BSjap17176-20260305- RMA ConResp-LLFA v3.docx

**PLANNING APPLICATION DM/25/2640
BROOKLEIGH PRIMARY SCHOOL, BURGESS HILL, WEST SUSSEX**

We refer to the Lead Local Flood Authority (LLFA) letter dated 28th January 2026, addressed to Mid Sussex Planning, in relation to the above-mentioned reserved matters planning application.

Risk of Surface Water Flooding with Climate Change

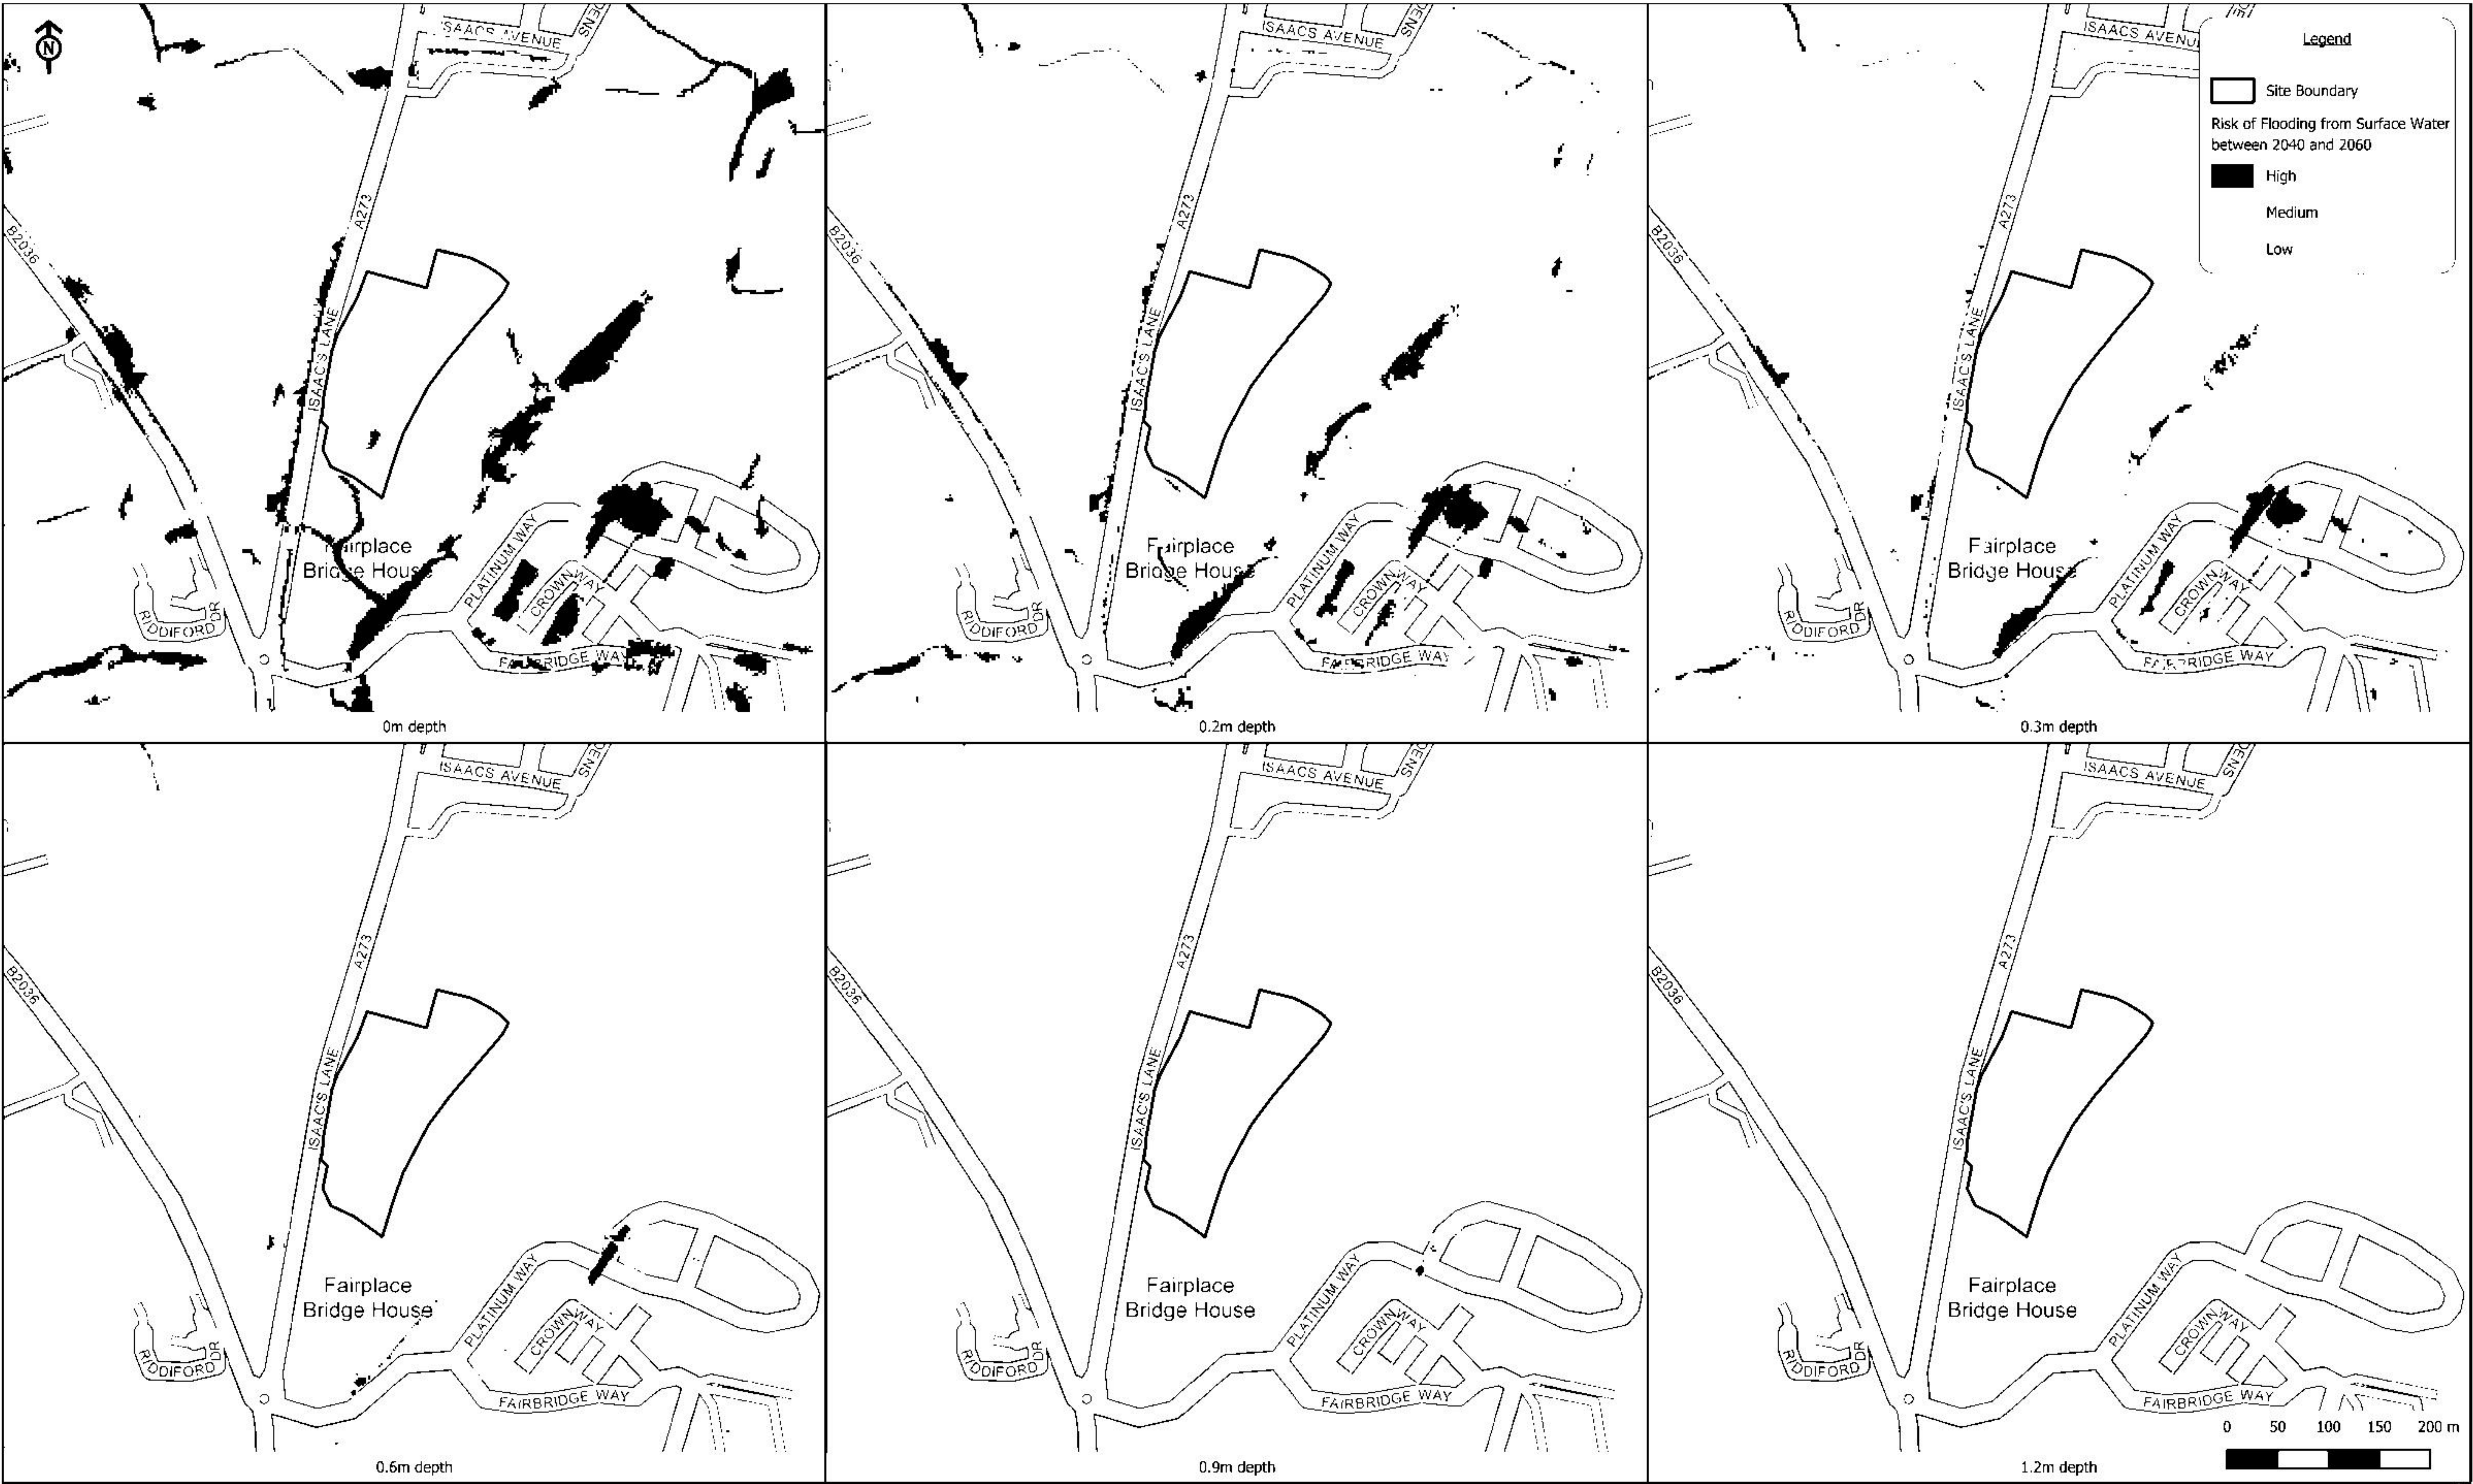
Focussing on the red application boundary for the primary school site only, we have extracted the NaFRA2 data published by Defra and reproduced the information onto the attached drawings 14176-CRH-XX-XX-FG-G-7023-P01 and 14176-CRH-XX-XX-FG-G-7024-P01 representing the current day RoFSW and the limited climate change scenarios for the period of 2040 to 2060. The Environment Agency plans to publish further climate change data in later updates to the NaFRA2 data, but these are not currently available.

Both drawings show the likelihood of surface water accumulations across the site within different anticipated flood depths. Of note the information does not show modelled flood depths, but rather the probability of occurrence of surface water flooding reaching that depth band. Analysis of that data indicates that the probability of occurrence of 0.0m depth of surface water accumulation where the proposed primary school building is to be located is classified as Low to Medium. The granularity of the area shown as Medium risk is very small in comparison. The probability of any surface water flooding occurring at any depth beyond the 0.0m is shown to be very low across all scenarios including consideration for climate change for the period up to 2060. This indicates that the probability of surface water flooding affecting the proposed development area is less than 0.1%, rarer than the 1 in 1000-year rainfall event. Of note, current guidance and all standards only require surface water flooding and drainage to be considered for up to the 1 in 100-year rainfall event (plus climate change), which is for a probability of occurrence greater than 1%.

Even when considering the area shown as High risk of flooding, the probability of occurrence for that event is only for a flood depth of 0.0m for up to the 2060 epoch, the probability of occurrence for any other event or flood depth is nil. From that review, the probability of the site being affected by surface water flood risk is very low to Low in all scenarios up to the 2060 epoch, based upon available information.
